RFI Response - 15 October 2021- Part One 757-763 George Street, Haymarket

RE: RESPONSE TO REQUEST FOR FURTHER INFORMATION - 757 - 763 GEORGE STREET, HAYMARKET

This letter has been prepared on behalf of Samprian Pty Ltd (the Applicant) in relation to their land at 757 – 763 George Street, Haymarket (the site). The site is the subject of a Planning Proposal (PP ref no PP-2020-1110.) that seeks to amend the height of buildings and floor space ratio (FSR) development standards that apply to the site under the *Sydney Local Environmental Plan 2012* (Sydney LEP 2012). The purpose of this letter is to respond to the issues raised by the City of Sydney (Council) in their Request for Information letter dated 22 February 2021.

Figure 3 – Former DCP Envelope (Left) and Revised DCP Envelope (Right) Source: Grimshaw

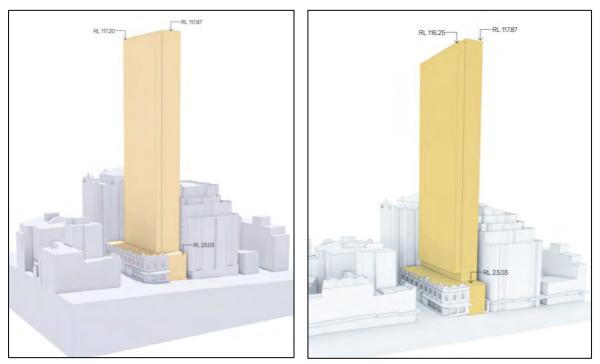
It is noted that the DCP envelope has been updated to account for the 2.6m vertical separation (refer to Figure 3). A comparison between the previous DCP envelope submitted alongside the Planning Proposal dated October 2020 and the amended DCP envelope is provided below. The DCP envelope has been revised to ensure that a future detailed design provides a minimum vertical separation of at least 2.6m measured from the heritage **building's ridge line and 5.4**m measured from the Floor to Floor Level (FFL) of the Sutton Forest Meat Building to the underside of the canopy.
